APPLICATION NO.	FILING DATE	FIRST NAMED INVENTOR	ATTORNEY DOCKET NO.	CONFIRMATION NO.
10/820,030	04/08/2004	Atsushi Murayama	0951-0136PUS1	7584

<b>Office Action Summary</b>	Application No. 10/820,030	Applicant(s) MURAYAMA, ATSUSHI	
	Examiner Luis F. Garcia	Art Unit 2613

## DETAILED ACTION

*Fig. 1.*

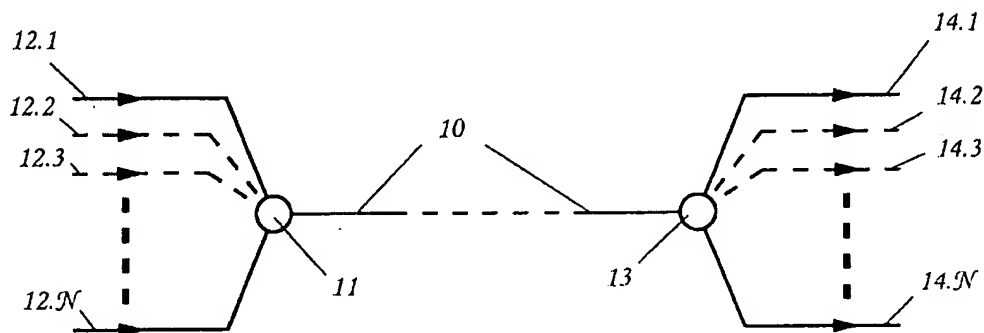
King further discloses comprising, as one or more means for transferring one or more clock synchronization signals from one or more input sides to one or more output sides (**FIG. 1 and col2 ln34-63 in which the clock signal is transferred from the input side (e.g 11-multiplexer) to the output side (e.g. 13-demultiplexer))**: transfer of one or more clock synchronization signals simultaneous with one or more signals at at least one of the respective channel or channels through use of the light-receiving element and the light-emitting element transferring one or more signals (**col2 ln34-67 to col3 ln1 and FIGs. 2-10 in which the clock signal is transferred simultaneously with the TDM signal (respective channels) through the use of the light emitting element and the light receiving element, e.g. the TDM signal is amplitude**

**at one or more input sides: a light-emitting element transferring one or more signals to at least one of the output side or sides (FIG. 1 (11-multiplexer) in which the multiplexer transfers OTDM signals to the output side(s) (e.g. to the demultiplexer-13). NOTE: a light emitting element for transmitting an optical TDM signal is an inherent part of the system, e.g. Mach Zehnder (optical type modulator) is used to received and decode the TDM signal; thereby, making the transmitted TDM signal an optical TDM signal created by a light-emitting element); and**

by the light-emitting element (**FIG. 1 (13-demultiplexer)** in which the demultiplexer (light receiving element) receives the amplitude modulated TDM signal (signal(s) imparted with changes in optical intensity produced by the light-emitting element). **NOTE: the demultiplexer consist of a Mach-Zehnder demodulator-col3 In1-19 or optical gates-col2 In64-67 to col3 In1); and**

an input circuit for receiving at least one input signal (**FIG. 1 (12.1-12.N: inputs) in which the inputs inherently receives an input signal from an input circuit, e.g. receives a data signal from the input circuit);**

an output side comprising a first light-receiving element (**FIG. 1 (13-demultiplexer) in which the demultiplexer (light receiving element) is located at the output side);**

a first light-emitting element communicating said time-divided signal from said input side to said output side (**FIG. 1 and col1 ln29-36 and col2 ln11-33 in which an optical TDM signal is transmitted from the input side (e.g. 11-multiplexer) to the output side (e.g. 13-demultiplexer). NOTE: the TDM signal is inherently transmitted via a light emitting element, e.g. light emitting element generates the optical signal); and**

FIG.11 Prior Art

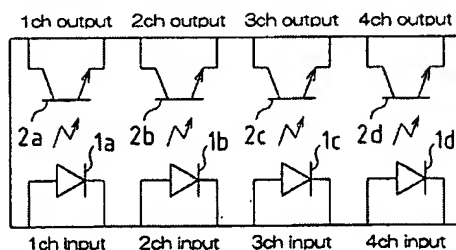
**Regarding claim 1**, AAPA discloses a multichannel photocoupler (FIG. 11)

at one or more input sides (**FIG. 11 (channel inputs)**); and

a light-emitting element communicating signals to one or more output sides (**FIG.**

**11 (output) in which the input sides communicates signals with the output sides**);

at one or more output sides: a light-receiving element receiving at least one of signals from the light-emitting element (**FIG. 11 in which the light-receiving elements at the output side (e.g. PD-2a-d) receive signals from the light-emitting elements (e.g. LEDs-1a-c).**

at one or more input sides: a light-emitting element transferring one or more signals to at least one of the output side or sides (**FIG. 11 (LEDs-1a-d) in which the LEDs (light emitting elements) transfer signals to the output side**); and

one or more level coupling means for carrying out level coupling with respect to one or more input signals at least one of the respective channel or channels so as to impart one or more changes in one or more optical intensities at the light-emitting element (**FIG. 11 (LED-1a) in which the LED is inherently intensity modulated in order to transmit channel data to the output as is the basic function of an optical communication system**) and for causing same to be transferred to at least one of the

output side or sides (**FIG. 11 (LED-1A) in which the data from input channel 1 is transferred to the output side (e.g. to output channel 1))**;

at one or more output sides: a light-receiving element receiving one or more signals imparted with one or more changes in one or more optical intensities produced by the light-emitting element (**FIG. 11 (2a-photodiode) in which the photodiode receives the signal produced by the light-emitting element (e.g. signal produced by LED-1a))**).
